Addendum No. 2

Subject: Stanton Elementary School
SDP Contract Nos. B-122C, B-123C, B-124C of 2016/17

MECHANICAL PLANT REPLACEMENT

CHIMNEY OPENING DETAIL

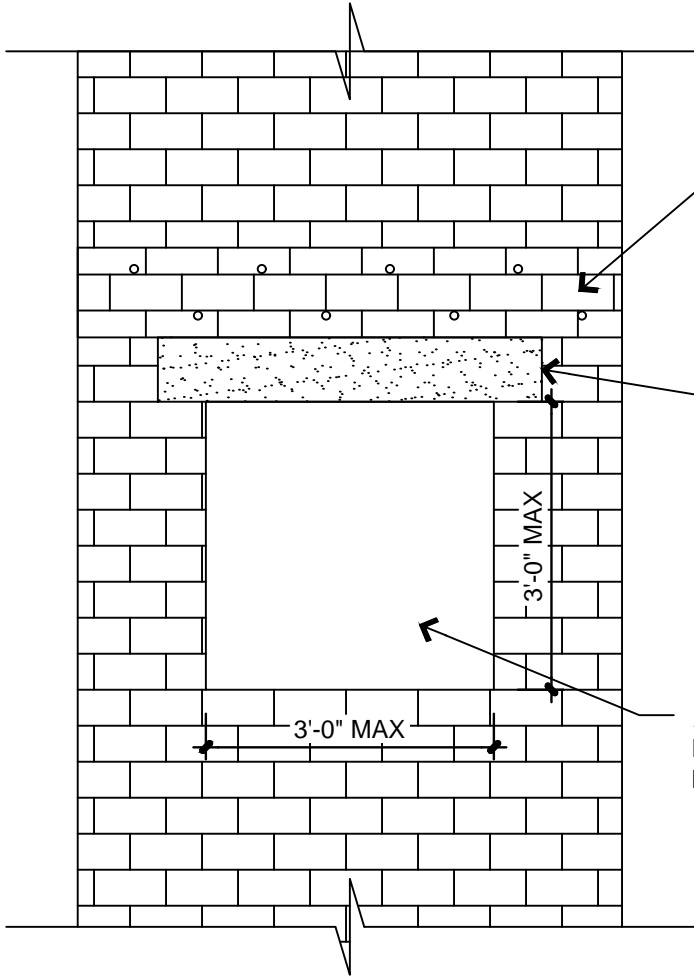
4. Drawing S2.0 – Chimney Opening Detail: Add Detail F4 as shown on attached Drawing SK-1

INSTALL TEMP. 2x12 ABOVE NEW CONC. LINTEL PRIOR TO ANY DEMOLITION. ATTACH 2x12 INTO BRICK W/ 5/8" EXPANSION BOLTS @ 16" O.C. STAGGERED. INSTALL BOLTS INTO TIE-BACK COURSE WHERE POSSIBLE

AFTER TEMP. 2x12 IS INSTALLED, REMOVE ENOUGH BRICK TO INSERT AN 8"x8"x4'-0" CONC. LINTEL W/ (2) #4 BARS AT d=6". AFTER NEW LINTEL IS INSTALLED, TEMP. 2x12 MAY BE REMOVED.

AFTER NEW LINTEL IS INSTALLED; REMOVE A 3'-0" x 3'-0" MAX OPENING IN BRICK CHIMNEY.

LOCATION: GENERAL CONTRACTOR SHALL PROVIDE OPENING IN EXISTING CHIMNEY ON THE SECOND FLOOR (CORRIDOR SIDE).

RESTORATION: AFTER NEW BOILER BREECHING IS COMPLETED BY THE MECHANICAL CONTRACTOR, THE GENERAL CONTRACTOR SHALL PROVIDE MASONRY INFILL OF THE OPENING. MASONRY INFILL SHALL MATCH FULL WALL DEPTH OF EXISTING CHIMNEY. FINISHED SURFACE SHALL BE FLUSH WITH ADJACENT WALL AND PAINTED TO MATCH THE EXISTING ADJACENT WALL.

NOTE: CHIMNEY WORK SHALL NOT BEGIN UNTIL EXISTING BOILERS ARE PERMANENTLY REMOVED FROM SERVICE.
